Official Transcript of Proceedings
NUCLEAR REGULATORY COMMISSION

Title: Advisory Committee on Reactor Safeguards
ESBWR Subcommittee

Date: Tuesday, June 3, 2008

ESBWR PRA and Severe Accident Management

Containment Fragility

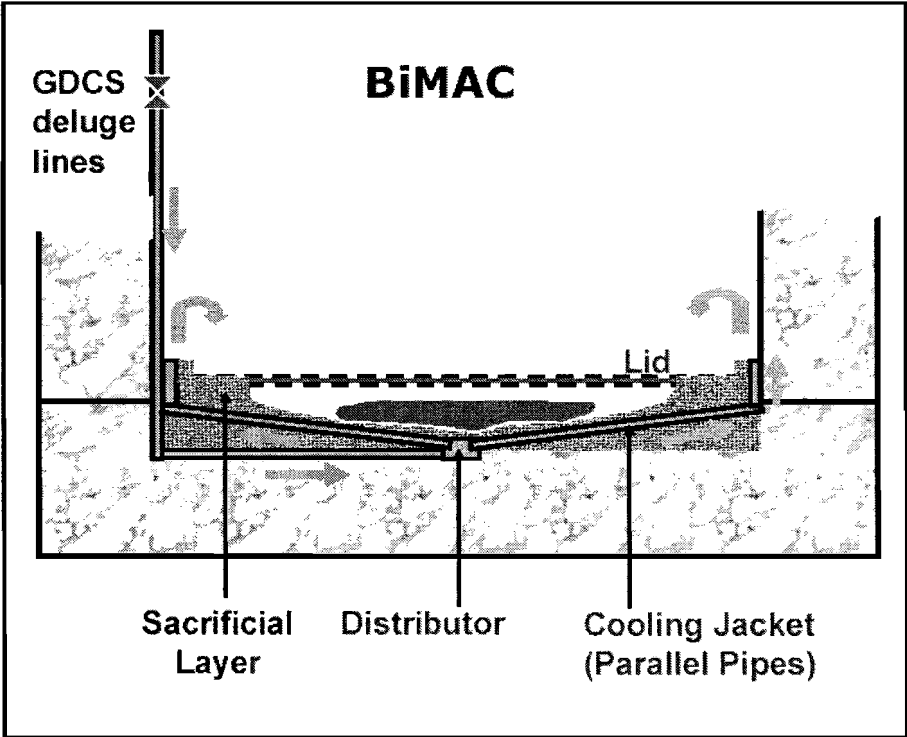
Significant open item

- Calculated upper drywell liner strain appears to exceed Level-C limit under conditions of 100% metal/water reaction
 - The documentation is not clear that service level C is presented in gauge while the metal/water results are presented in absolute
- Temperature boundary condition for drywell head in finite element model set at 110 °F versus drywell air space temp of 500 °F
 - Analysis using 500 °F is presented in rev 5 of the DCD
